Board Agenda Item #:	IV A – Action Item
Date:	February 13, 2020
To:	Magnolia Educational & Research Foundation dba Magnolia Public Schools (“ <b>MPS</b> ”) Board of Directors (the “ <b>Board</b> ”)
From:	Alfredo Rubalcava, CEO & Superintendent
Staff Lead:	Patrick Ontiveros, General Counsel & Director of Facilities
RE:	Recommendation of Ad Hoc Committee to Board to Approve MSA-1 Change Order Requests

The Ad Hoc Committee recommends and moves that the MPS Board approve change order requests 37 to 54 up to \$176,614.96 as presented by Oltmans Construction Co. (“**Oltmans**”) for the new construction project for the benefit of MSA-1 at 18220 Sherman Way (the “**Project**”) with the payment amount to be confirmed by MPS Staff based on a review of all change order requests and back-up.

Oltmans Change Order Requests

SHEET TITLE:	<b>SECOND FLOOR H.V.A.C. PLAN</b>
PROJECT:	MAGNOLIA SCIENCE ACADEMY 18220 SHERMAN WAY RESEDA, CA 91335
OWNER:	
DATE:	03-04-19
SCALE:	AS NOTED
DRAWN BY:	--
CHECKED BY:	--
JOB NUMBER:	18-3023
SHEET NUMBER:

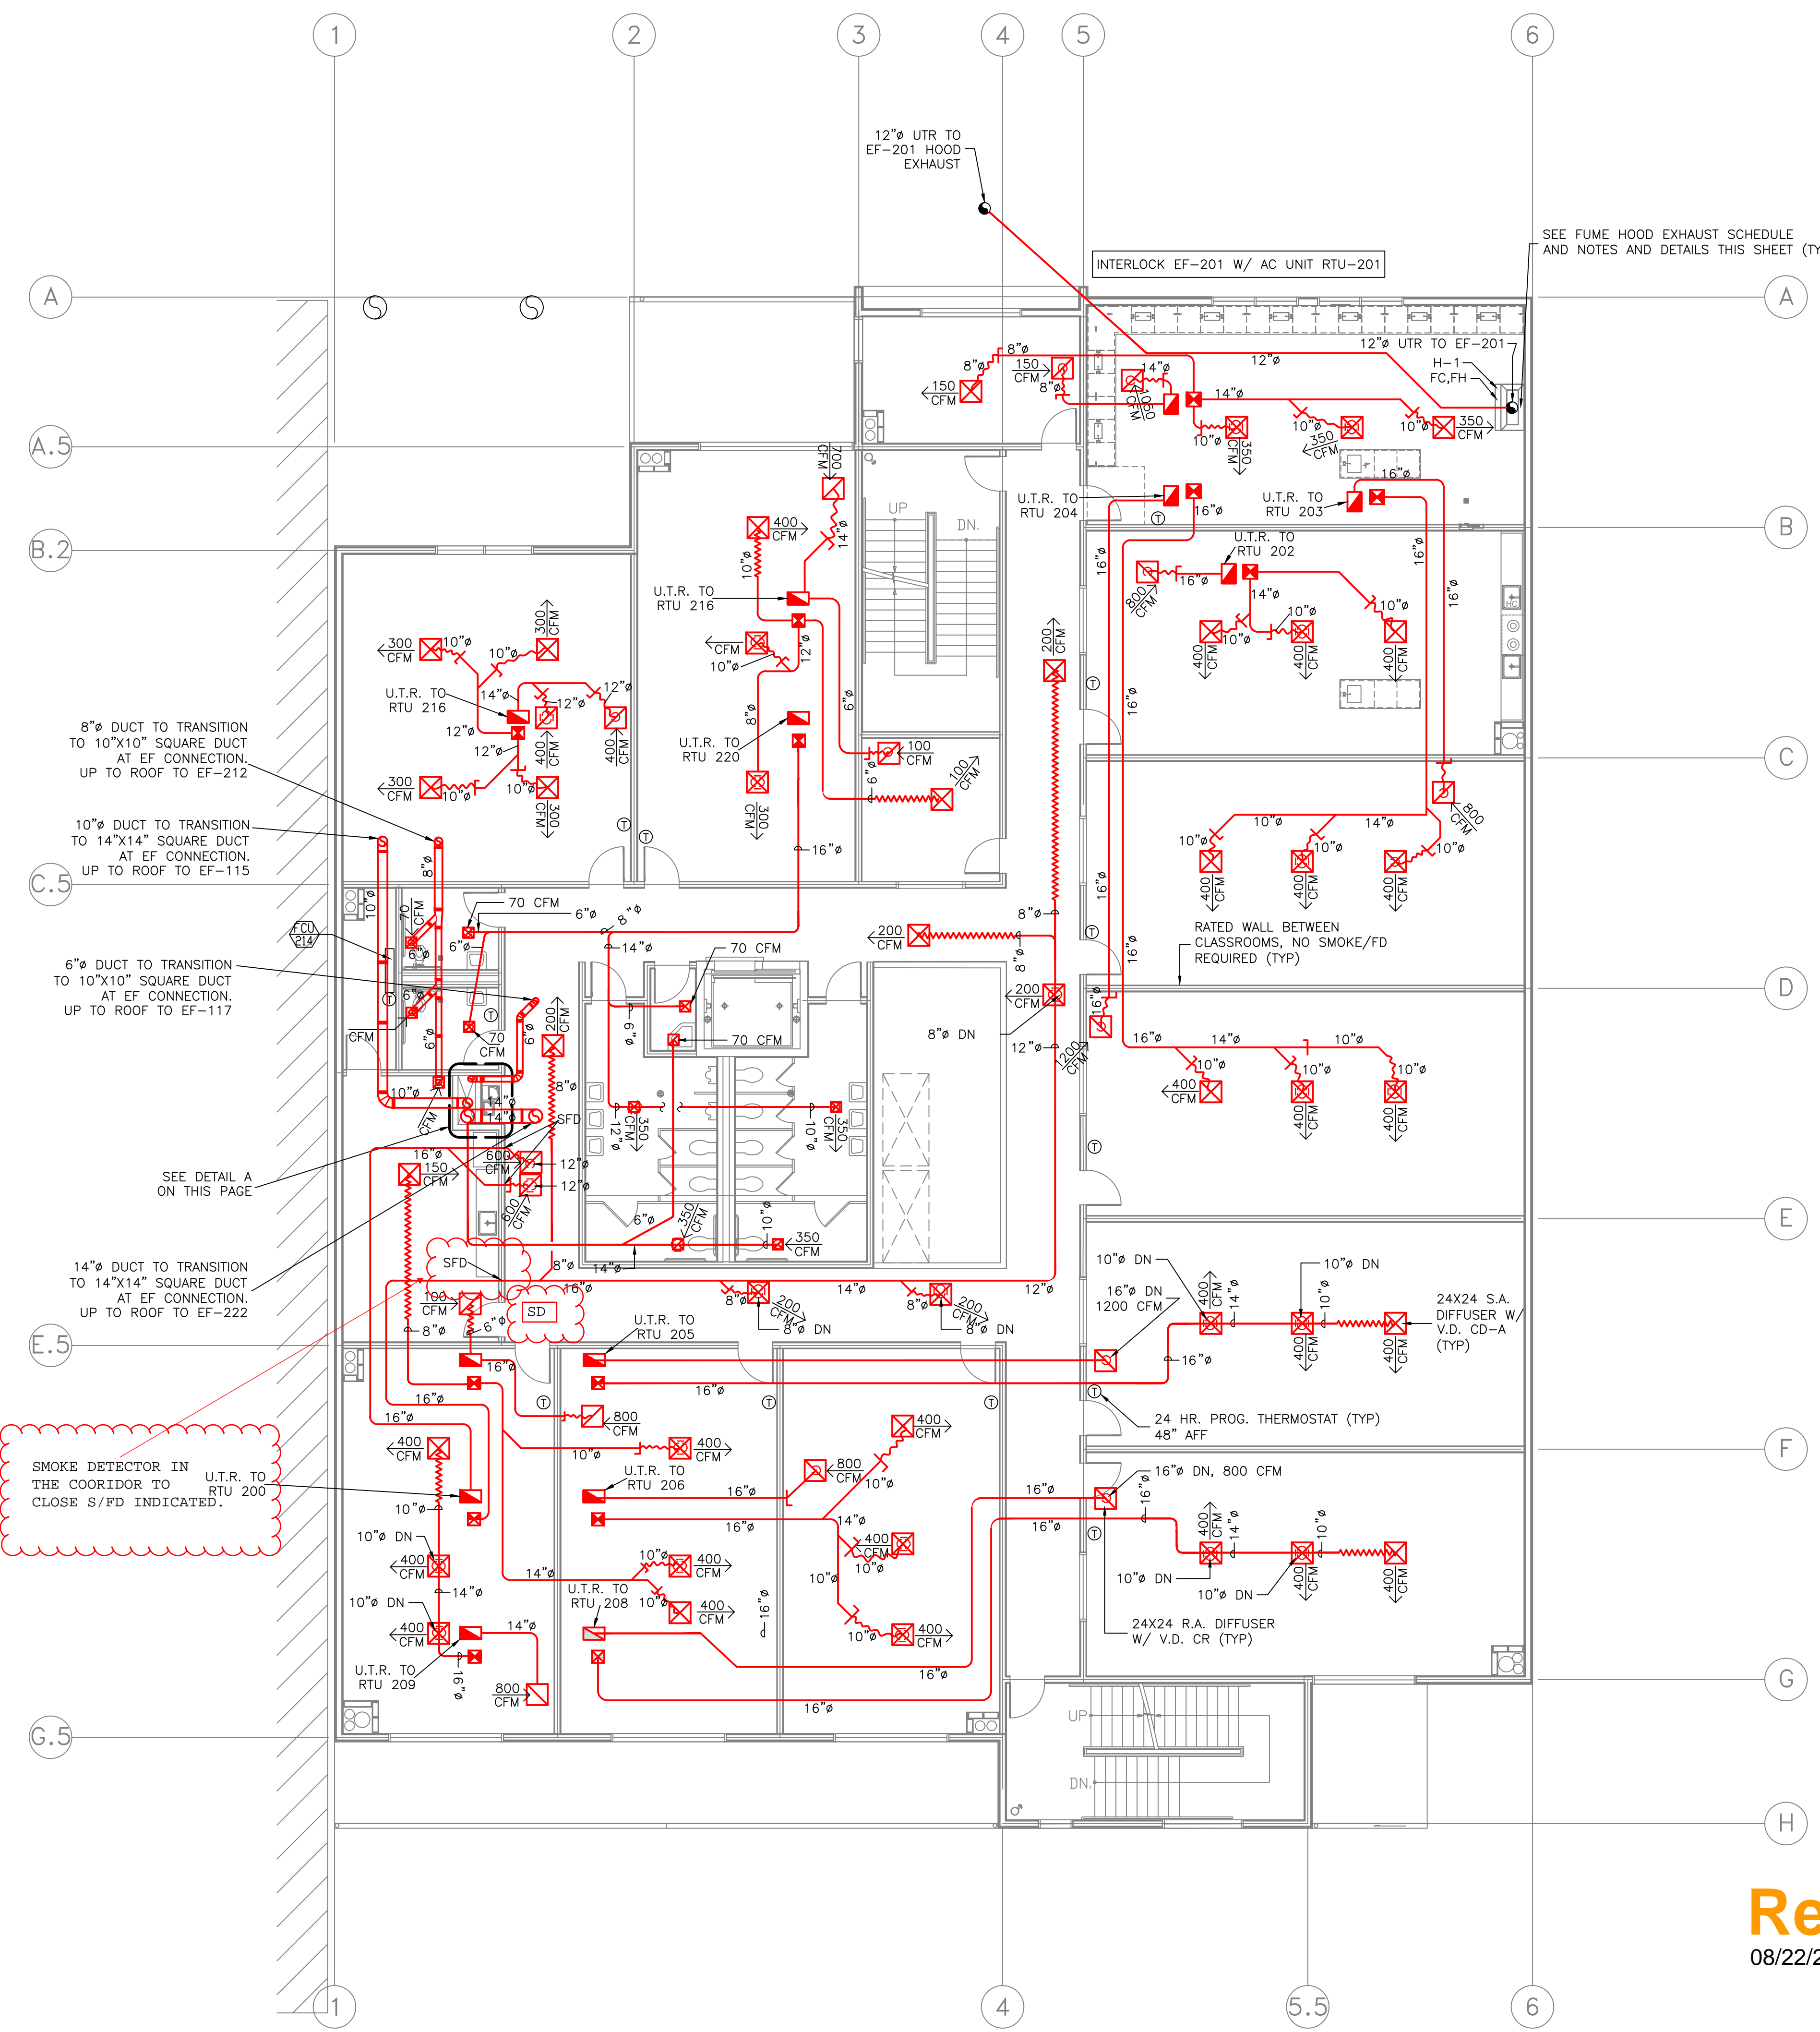
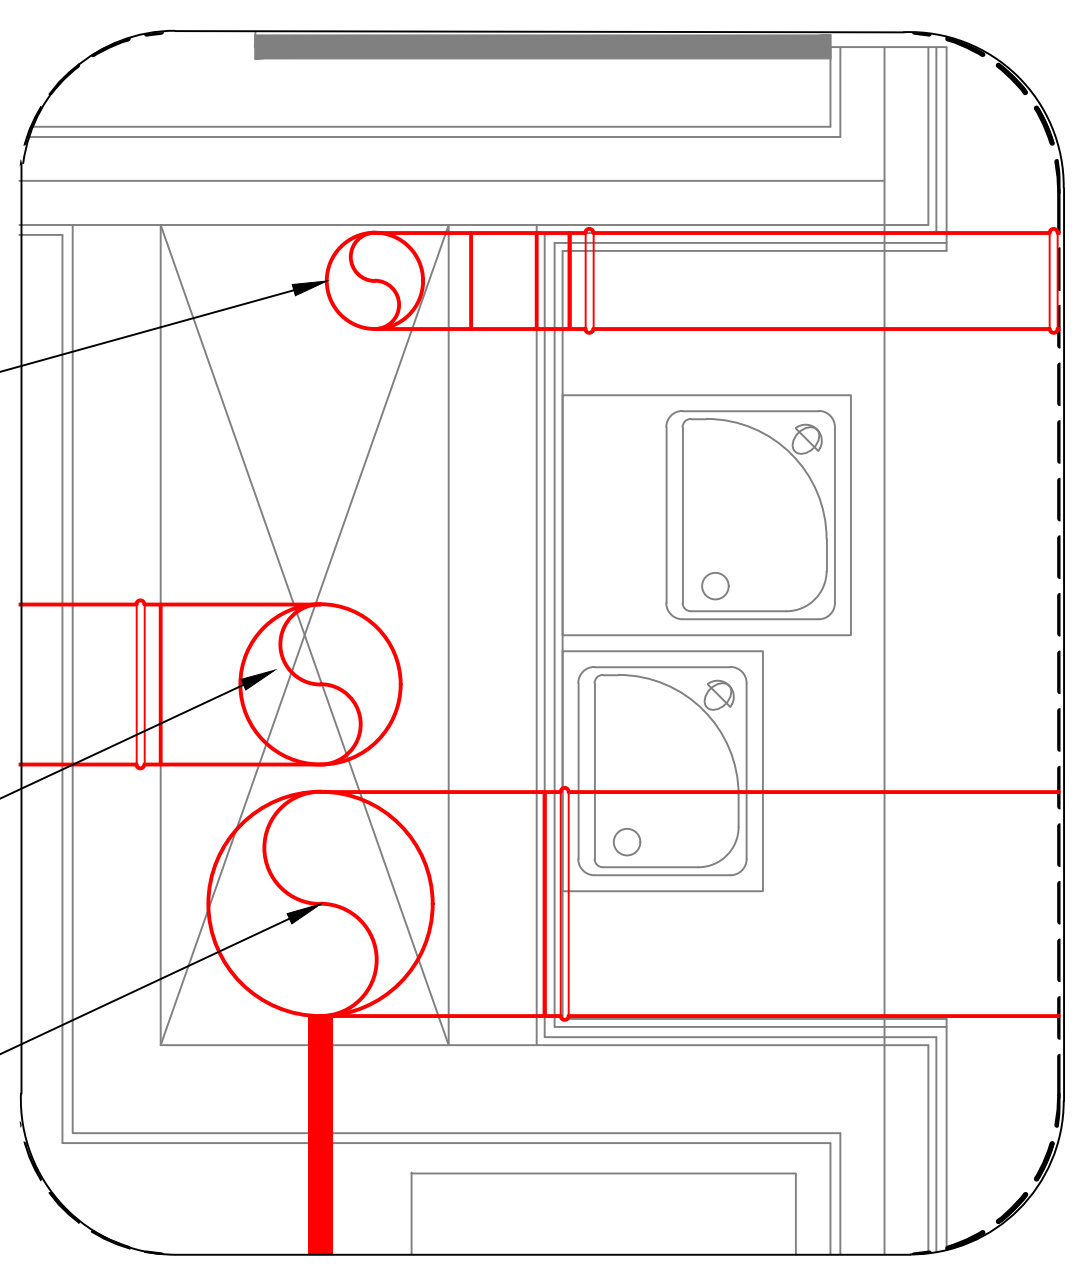
1. From shop drawing SD-2.0, rooms 100,101,102,103,104,110,1109,112,113,114. From shop drawing SD-3.0, 1 smoke detector is required within five feet of the smoke/fire damper shown on the plan I've attached and the s/fd clouded.
  2. Shut down all the units as indicated in 1.
  3. Duct detectors are not required.
  4. Yes, on the second floor SD-3.0, near kitchen, see clouded.
  5. Yes.
  6. Only in room 109. return air from any of the other room will reach rm. smoke  
**Answered By:** detector.
  7. Smoke detector in corridor, second near kitchen will suffice.
  - Date:** 8. Confirmed. Please verify with electrical.
-

PLACE SMOKE DETECTOR WITH IN 5 FEET OF S/PD IN THE RM TO COVER BOTH.

**1 WEST WALL**

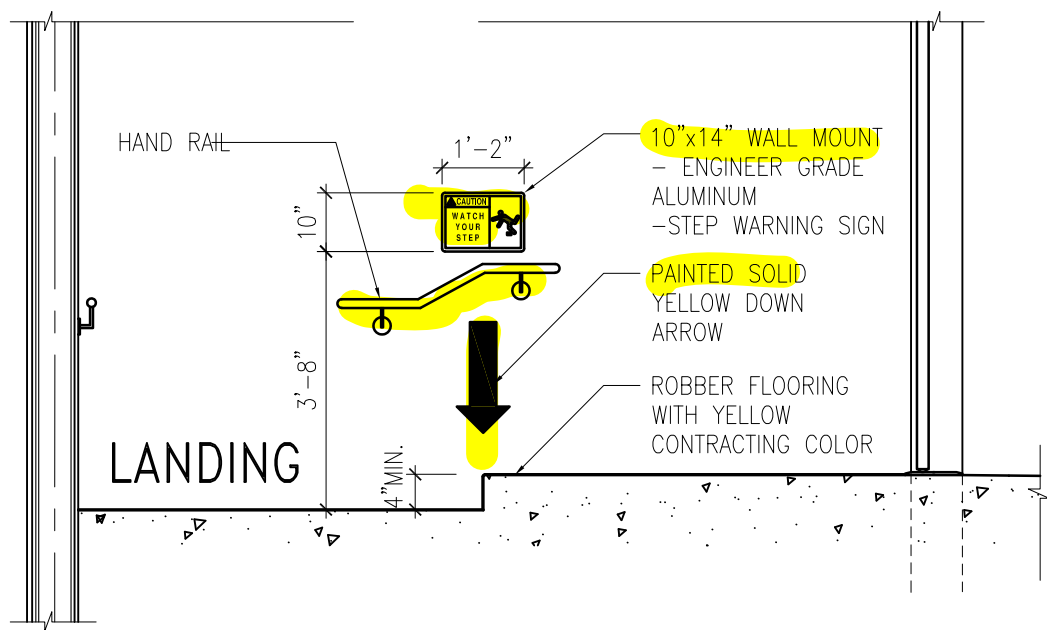
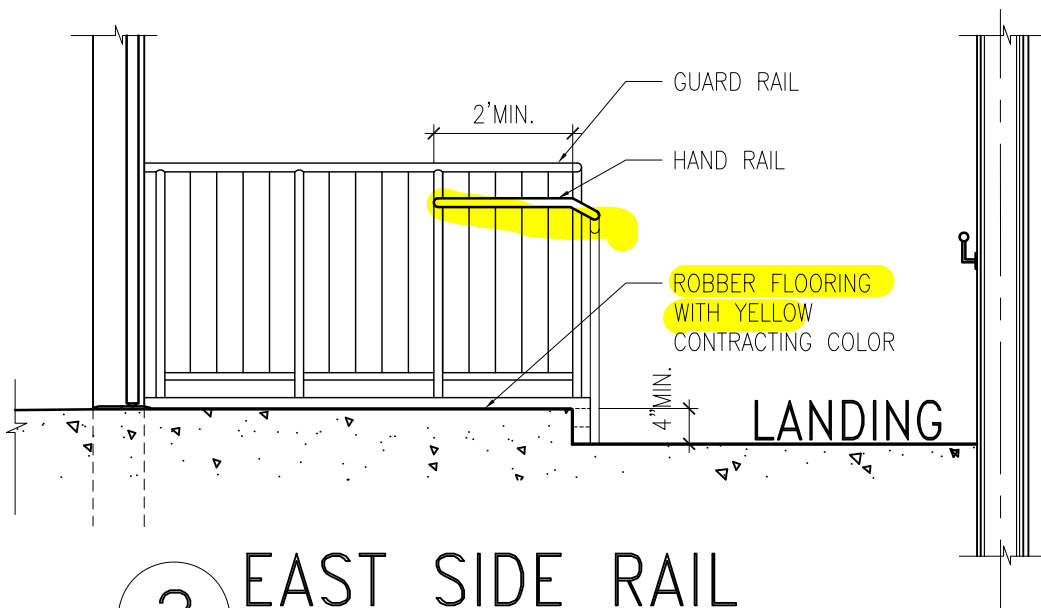
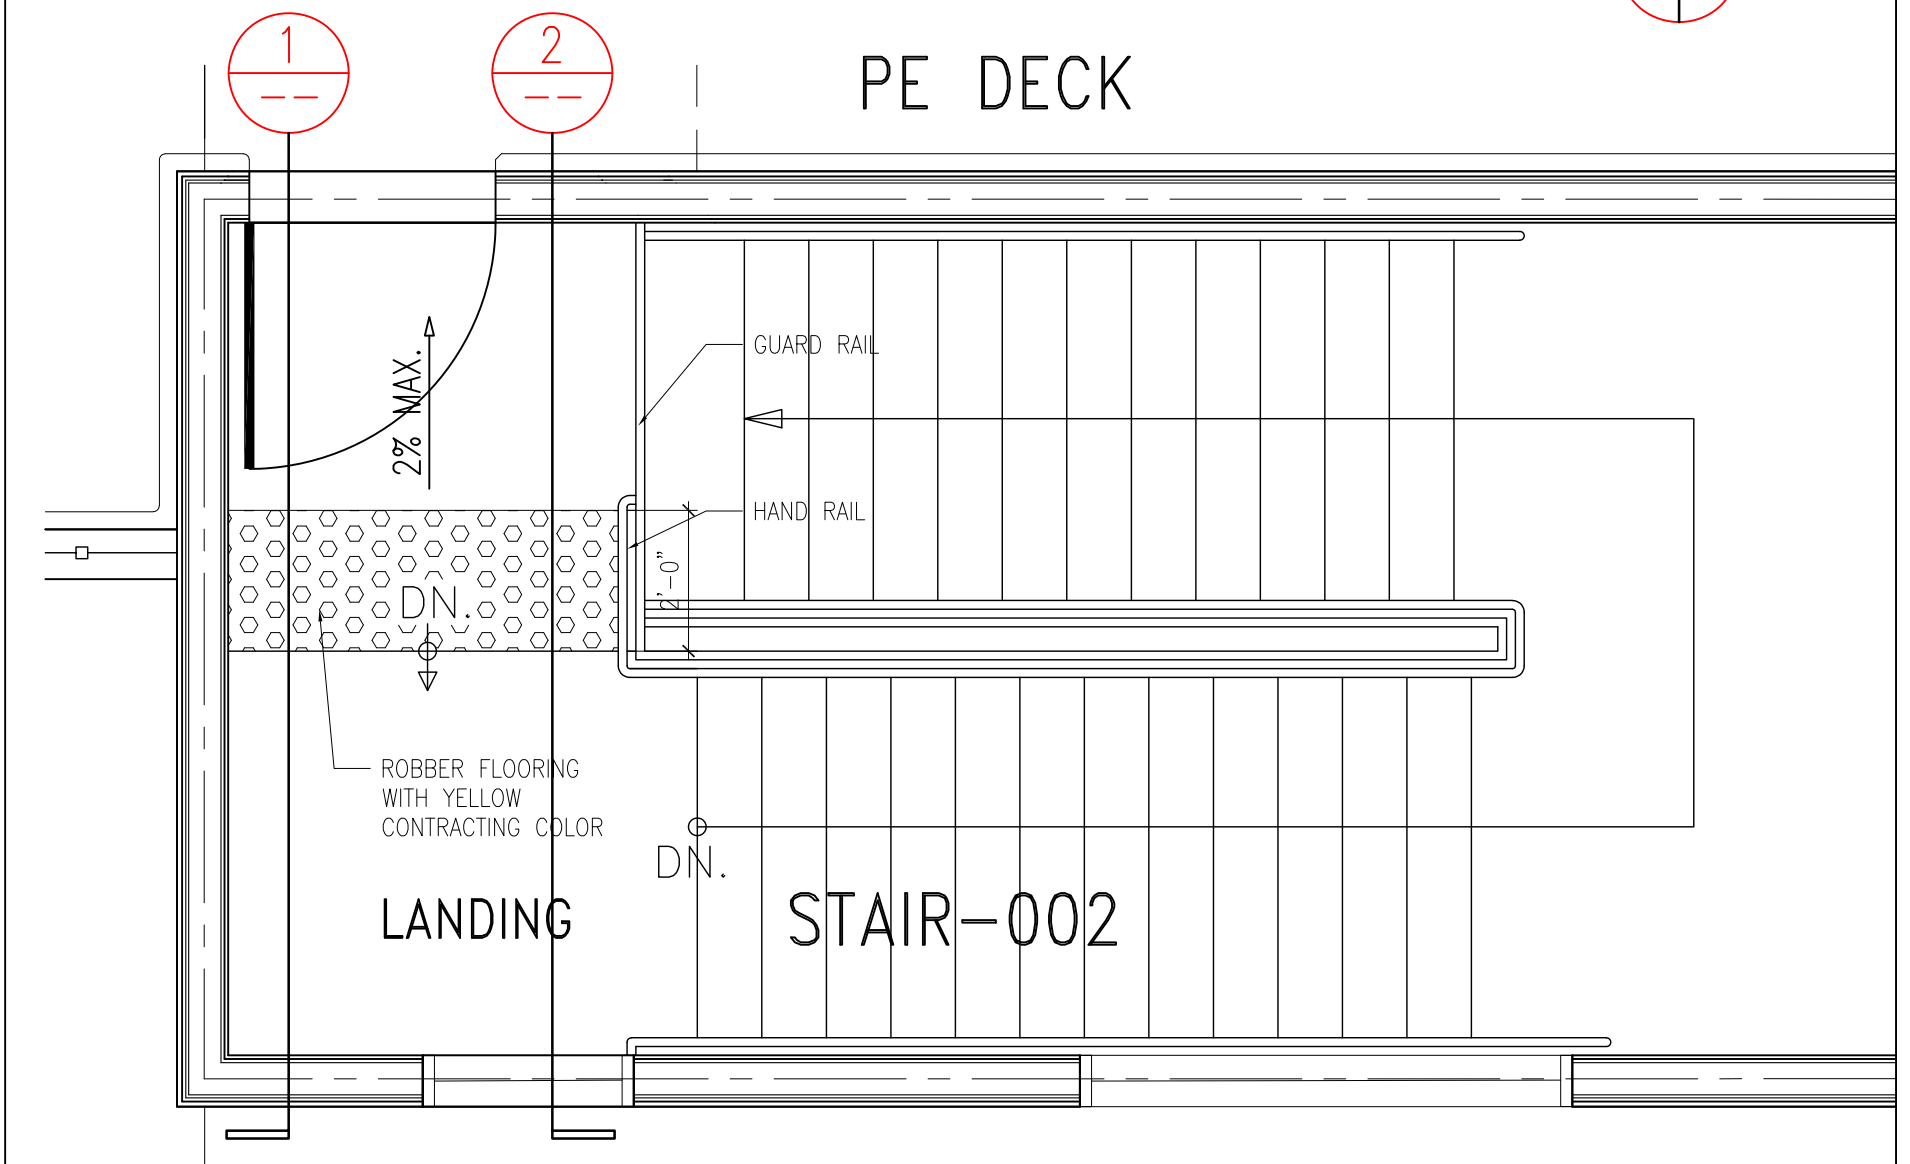
3. Adjust hand railing at the landing due to added step (stair #2, roof top only) on the previously approved shop drawing 051200-03 Stairs Shop Drawings FAC 071018.

Add hand rail & backing per jobsite walk after OAC 5/8/19.

Change hand rail & backing per jobsite walk after OAC 5/8/19.

**Suggestion:****Answer:** **Accept Suggestion**

See attached SK-040.

8/A9.3 - RFI 173 Chem Lab #201

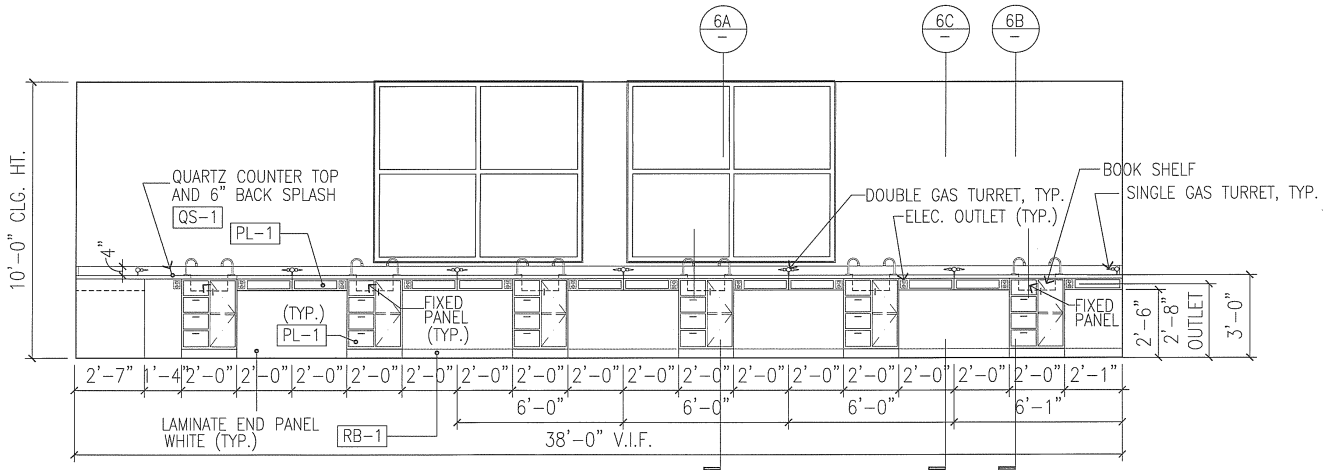
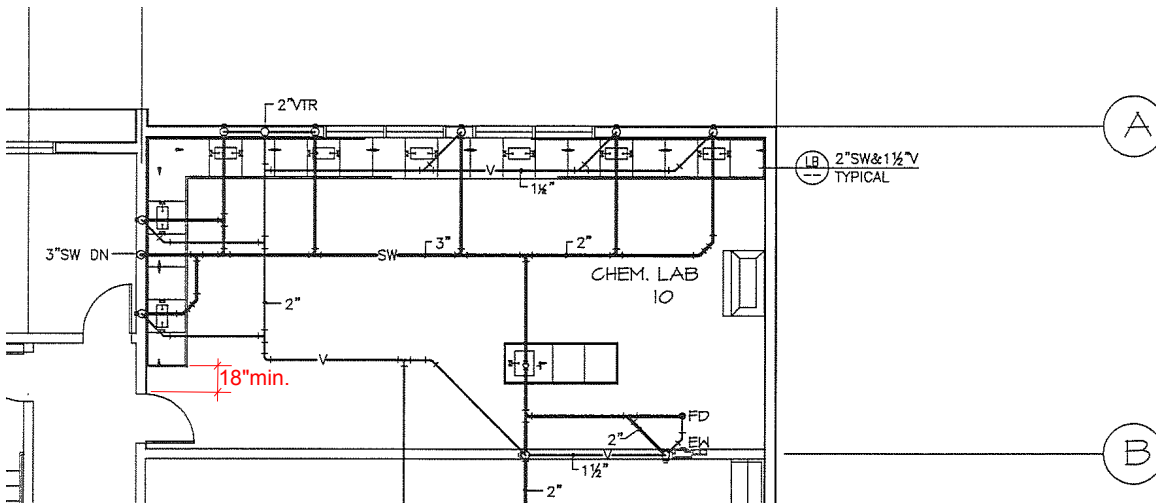
The Chemistry Lab room #201 has full height windows facing North above the lower cabinets. See A9.3 detail 8. The windows are type "A" found on A10.1. The plumbers have no way to run their waste and vents. We have large structural beams above and below. The 18" cavity between the windows are full of structural posts etc. There is no room to run a vent or waste up or down this 18" cavity.

Provide about 4" full-height furring on north wall to accommodate the plumbing work.

Adjust the cabinet work at the north-west corner.
